RESPONSE TO NRC

LIQUEFACTION QUESTIONS

PALO VERDE NUCLEAR GENERATING
STATION

October 17, 1975

CYCLIC STRENGTHS, 30'-50'
PITCHER SAMPLES
Figure 2F-10

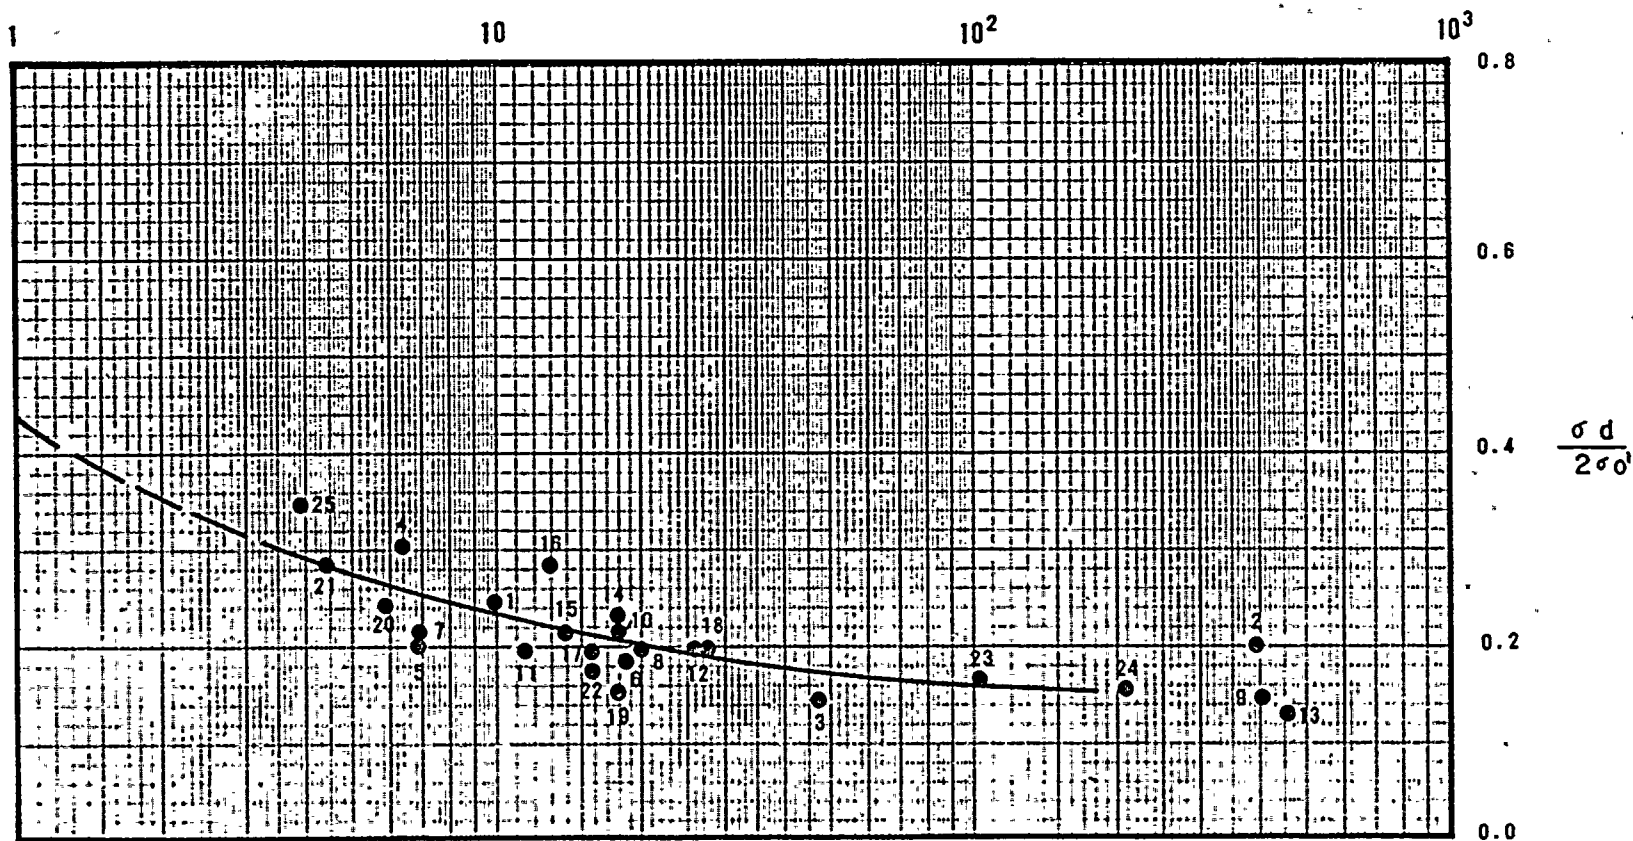
Demonstrate that analysis based on in situ data only is conservative. Compare the presented analysis with the laboratory test data analysis. Show how this data is used in the analysis.

A summary plot of the laboratory cyclic strengths of the Pitcher samples obtained between depths of 30 to 50 feet is presented on Figure 2T-10. The average soil characteristics (dry density, D_{50} and percent of fines) from the Pitcher samples are summarized in Table 2T-9c.

Figure 2F-10c

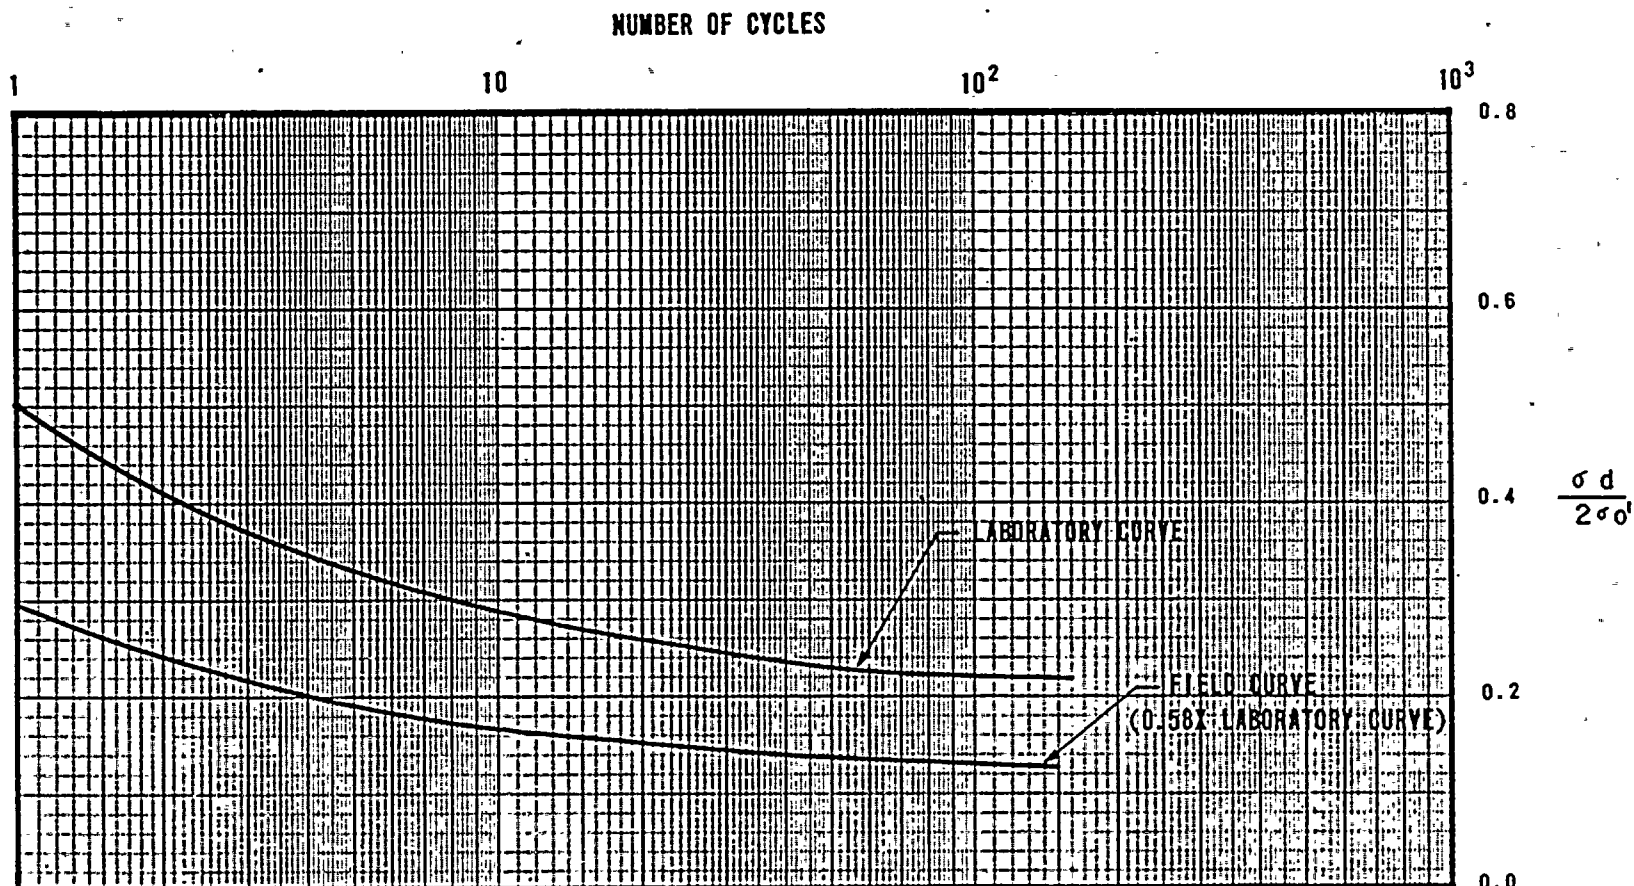
The factor of safety (1.2) for liquefaction potential is too low. Reevaluate the liquefaction potential for the site. If you cannot demonstrate that the factor of safety is 1.5 or higher based on undisturbed sample test data, provide a plan to lower the groundwater level under and around the Category I structures and components, or an alternate plan, to preclude liquefaction risks. A factor of safety of 1.3 is required for remolded sample data evaluations.

For the liquefaction analyses, the lower average cycle strength curve of the block samples was selected as being a conservative representation of the in-situ granular materials encountered between depths of 30 to 50 feet at the Palo Verde site. Despite the overconsolidated nature of the sands, a reduction of the laboratory curve by a factor (c_r) of 0.58 (De Alba, 1975) results in a conservative "field adjusted" strength curve which accounts for possible strength over-estimates caused by the cyclic triaxial apparatus. Design laboratory and field dynamic curves are presented in Figure 2T-10c.

CYCLIC STRENGTHS, 70'-80'
PITCHER SAMPLES
FIGURE 2T-10d

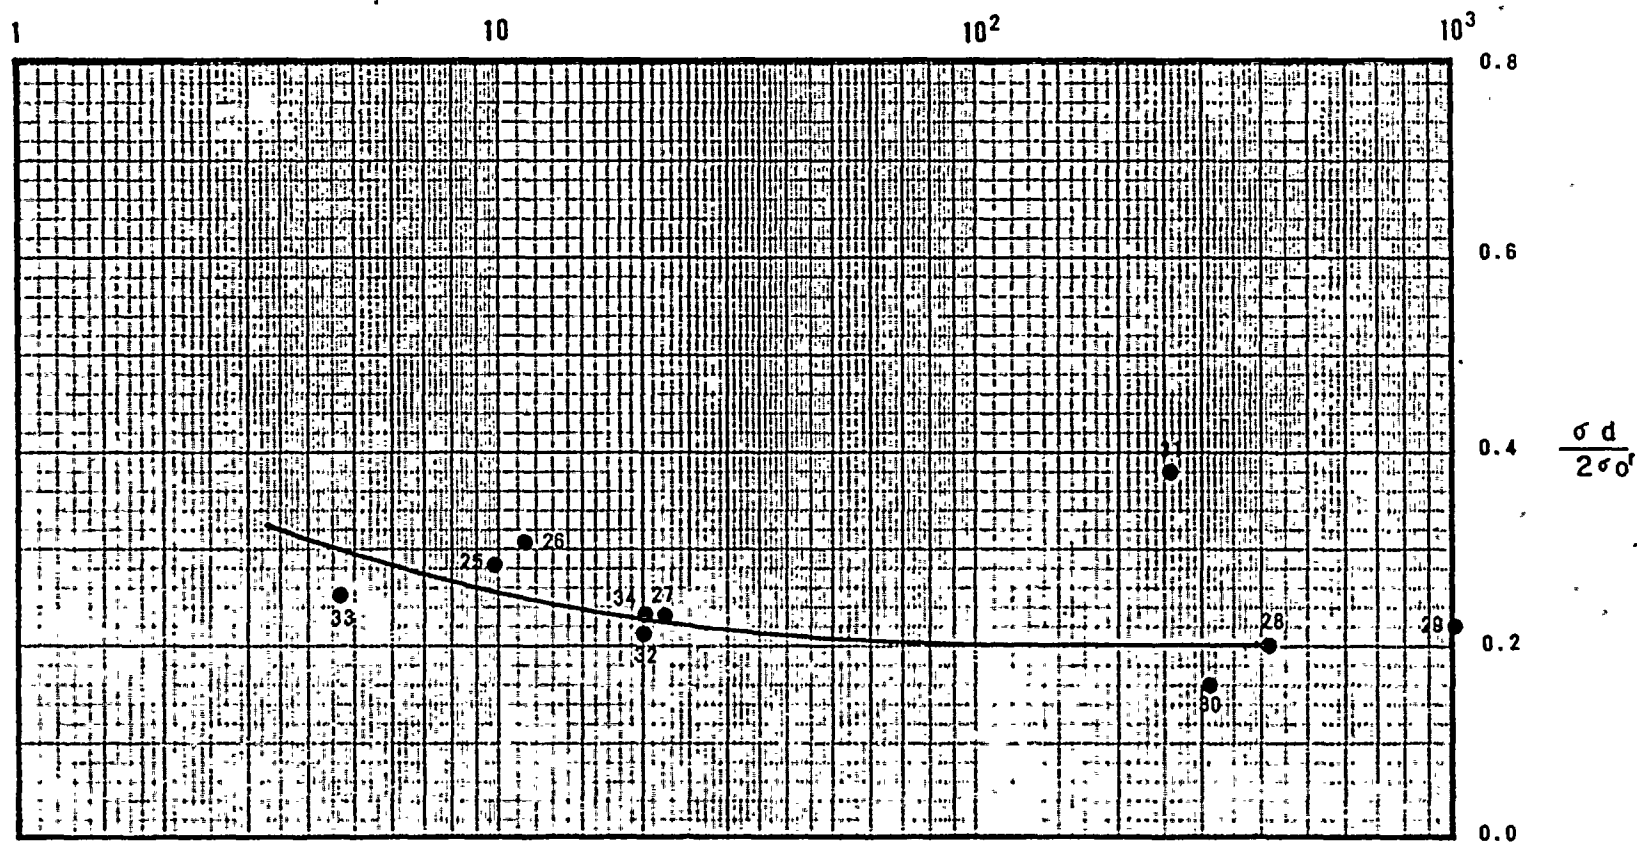
Expand your discussion and analysis of "sequence F" liquefaction potential. Provide soil sections and list the borings and test results used to conclude that this interval presents no stability problems.

To emphasize the lack of a liquefaction potential within soil sequence F, an evaluation was made of the cyclic strengths of the granular soil portions. The only cyclic strength results available for sequence F were for samples obtained by the Pitcher barrel sample technique. These results are shown on Figure 2T-10d and a summary of pertinent test data is listed in Table 2T-9b.

Figure 2T-10g

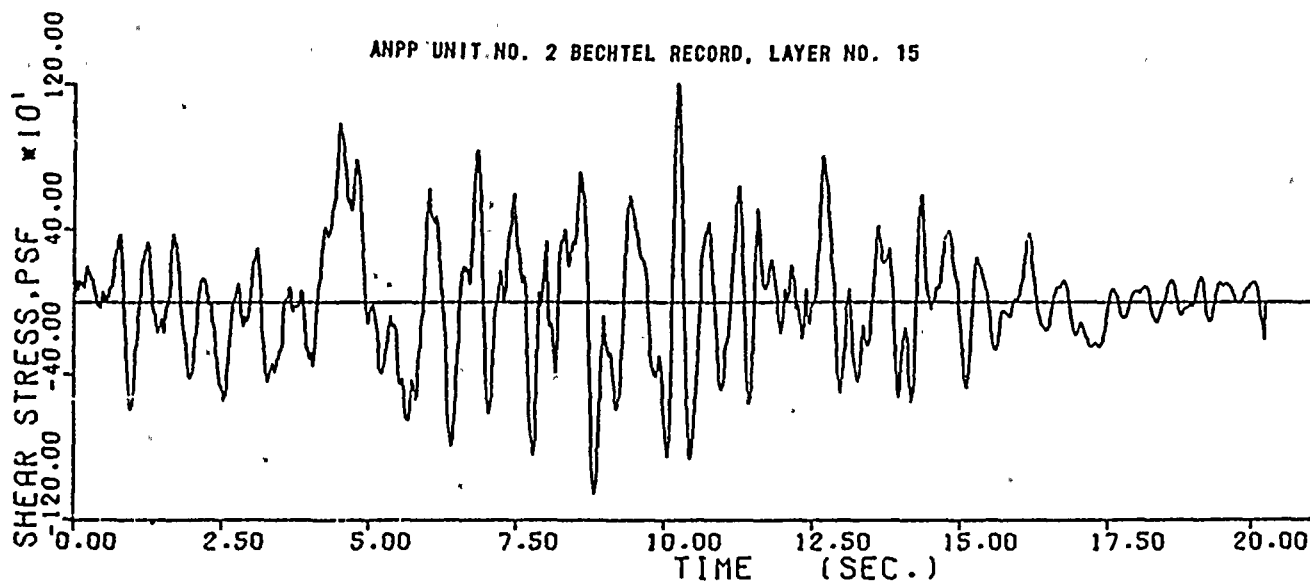
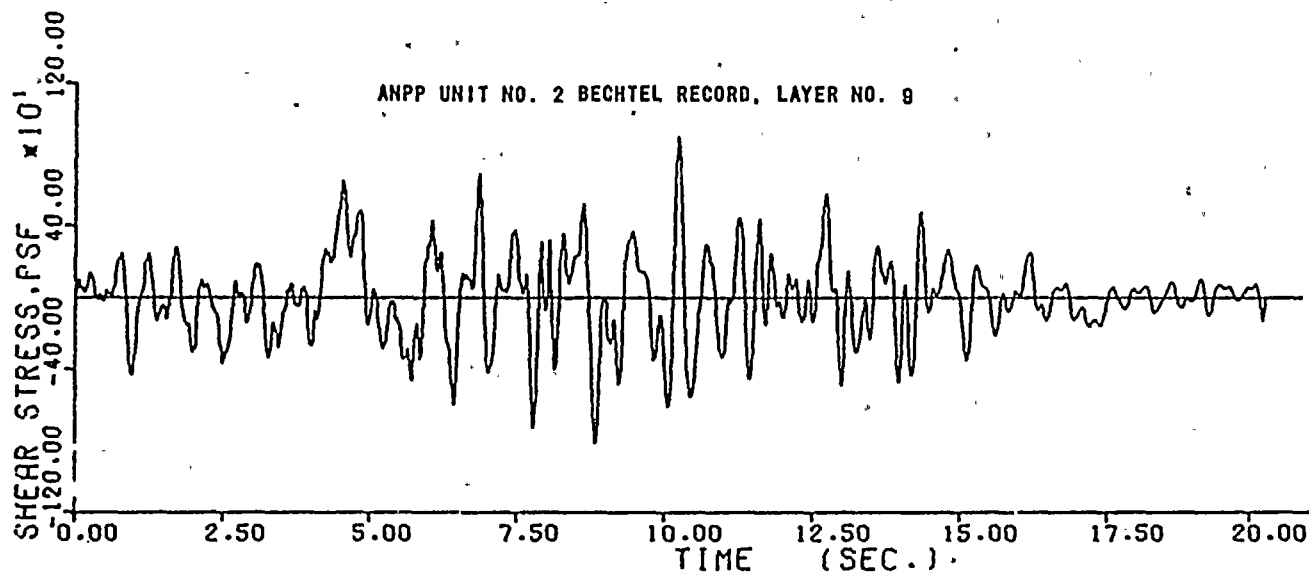
Clearly describe the dynamic input motion. The input motion acceleration time history and the induced shear stress time histories, for the depths presented in Tables 2T-10 and 11, representing the SSE condition, should be presented and discussed as well as cross referenced.

In addition to the peak acceleration and maximum shear stress data obtained from the soil column analyses described in the section Response of Soil to Dynamic Loading, shear stress-time histories were obtained for selected soil layers. These stress histories were used to determine the number of equivalent cycles of an average stress intensity that each input record induced into the site soils. The shear stress histories obtained for Layer Nos. 9 and 15 within the Unit 2 and 3 soil models are shown on Figures 2T-10g and 10h for the Bechtel input record.
